CITY OF RINGWOOD
RINGWOOD LAKE RESERVE
MINERS COTTAGE
FLOOR PLAN

DRAWING NUMBER
1192
SHEET 2 OF SHEETS

FLOOR PLAN
SCALE - 1/2" = 1' 0" (METRIC EQUIV. SHOWN)

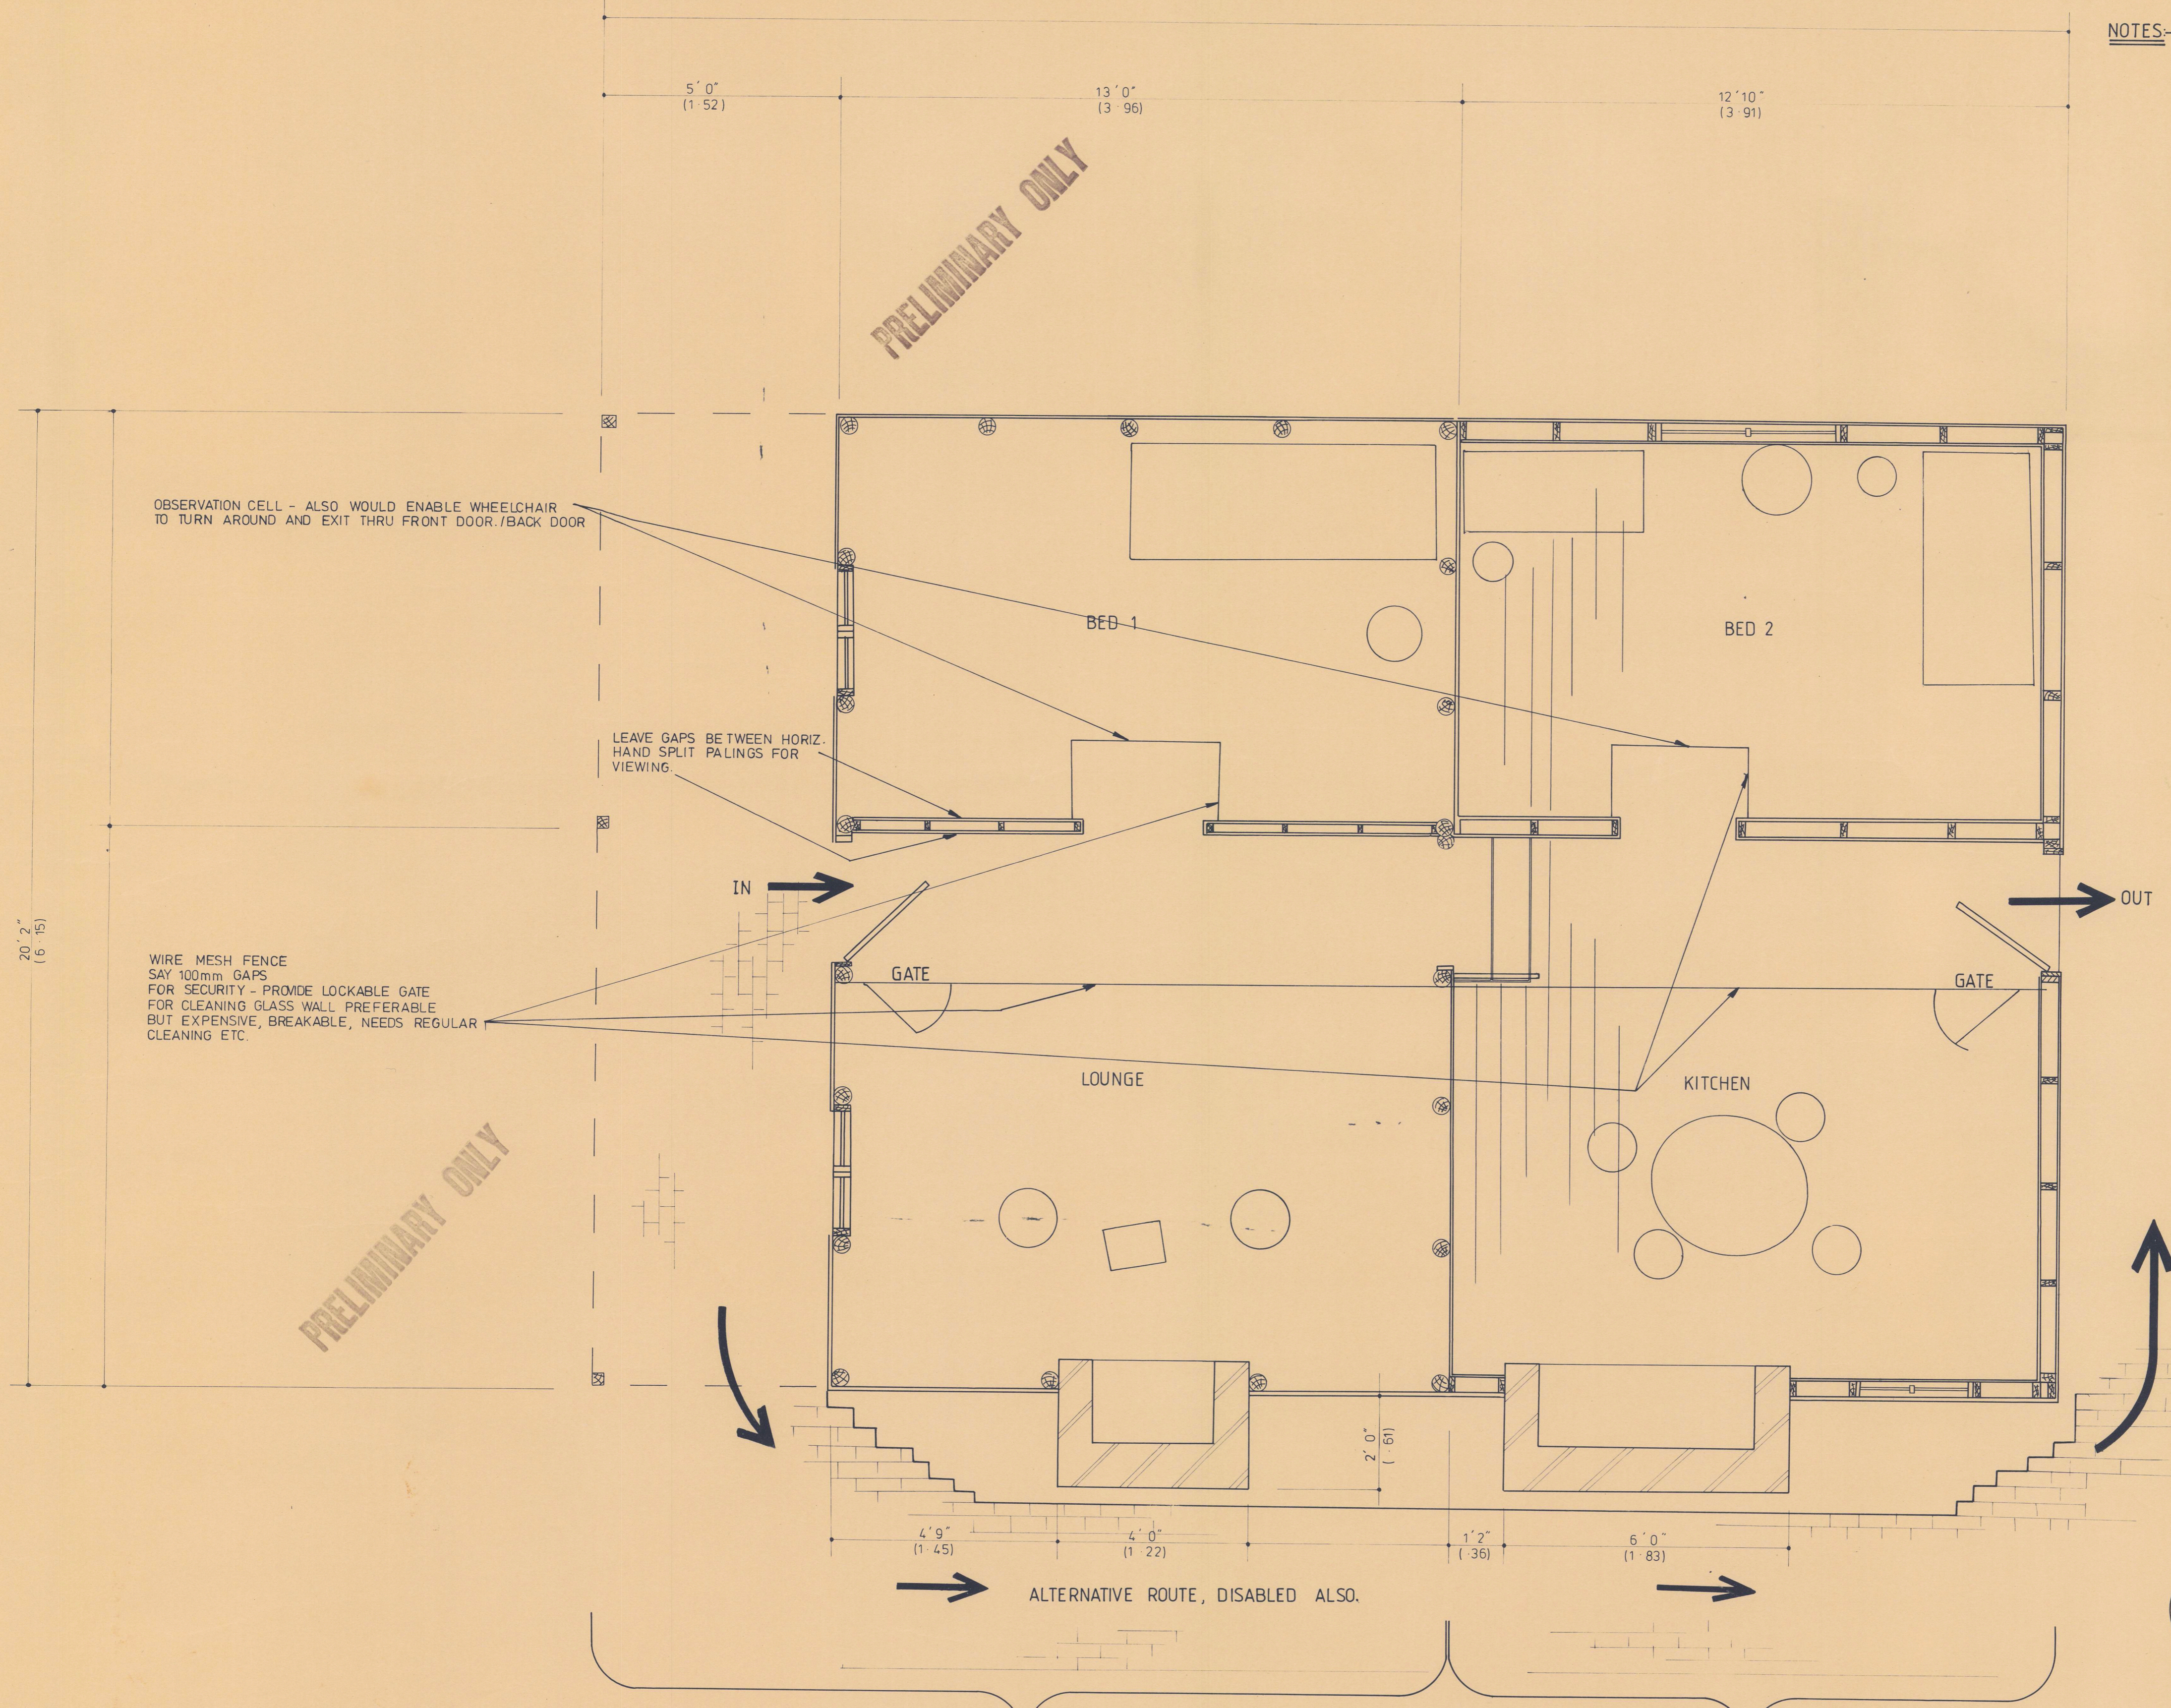
- NOTES-**
1. IS THERE A NEED FOR AUTO SPRINKLING SYSTEM ?
 2. DESIGNER CONSIDERS THAT PROVISION FOR THRU WHEEL CHAIR TRAFFIC i.e. 12" LONG RAMP (15" DROP) WOULD SPOIL THE INTERIOR OF COTTAGE CONCEPT. SUGGEST THAT A SUITABLE PATHWAY AROUND COTTAGE AND ENCOURAGEMENT FOR WHEELCHAIR TO ENTER EACH STAGE BY ITS EXTERIOR DOOR ALONG WITH ENOUGH SPACE TO TURN AROUND.
 3. TYPE OF VIEWING WALL DEPENDS ON LEVEL OF SUPERVISION WOULD HAVE TO BE OF HIGH LEVEL TO AVOID FLOOR TO CEILING SECURITY WALL e.g. WIRE MESH. GLASS WALLS TENDS TO REDUCE ATMOSPHERE OF AREA BEING VIEWED.
 4. SOME INTERNAL LIGHTING SHOULD BE USED. PREFERABLY INDIRECT TO HIGHLIGHT SOME FEATURES OF CONSTRUCTION FURNITURE ETC.
 5. SECURITY, LIGHTING SHOULD BE ALLOWED FOR.
